Parallax “Propeller ProtoBoard and Proto Board USB”, 5V regulator oscillation Repair Procedure

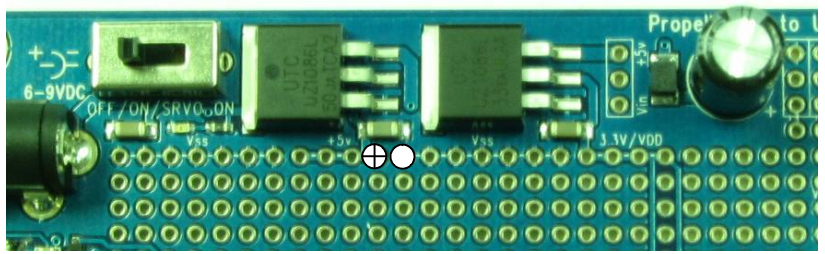
STEP 1: Solder a 10uF tantalum capacitor in the indicated holes. Place the pin marked with a red line in hole marked ⊕ and the other pin in the hole marked ○

STEP 2: Finished board will look like this.
